BUILDINGS ORDINANCE (Chapter 123)
(Section 35)

**Superseding Order by the Building Authority under section 24(1)
of the Buildings Ordinance (Cap. 123) and under section 46
of the Interpretation and General Clauses Ordinance (Cap. 1)**

Order No. : CBZ/TC/000241/10/NT

To : The owner of
2/F
NO.67 SAN SHING AVENUE
NORTH
NEW TERRITORIES

2nd FLOOR PLAN 二樓平面圖

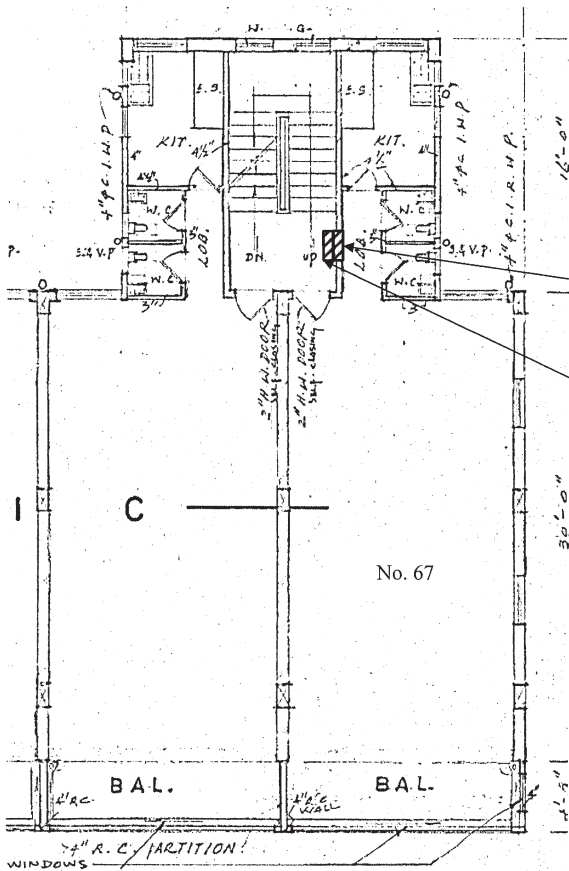
- (i) A metal gate at the entrance opening out on to the staircase; and
- (ii) A door opening formed in the staircase enclosure wall.

- (a) As a result of the building works at Item (i) above, Regulation 41(1) of the Building (Planning) Regulations, which requires the building to be provided with such means of escape in case of emergency as required by the intended use of the building, has been contravened.
- (b) As a result of the building works at item (ii) above, Regulations 90 of the Building (Construction) Regulations, which requires the building to be designed and constructed so as to inhibit or provide adequate resistance to the spread of fire and smoke; and to maintain stability of the building in case of fire, has been contravened.

Item (ii)
第(ii)項

Item (i)
第(i)項

- (a) demolish the said building works described under item (i) above; and
- (b) reinstate the parts of the building so affected by the building works under items (i) and (ii) above in accordance with the plans approved by the Building Authority.
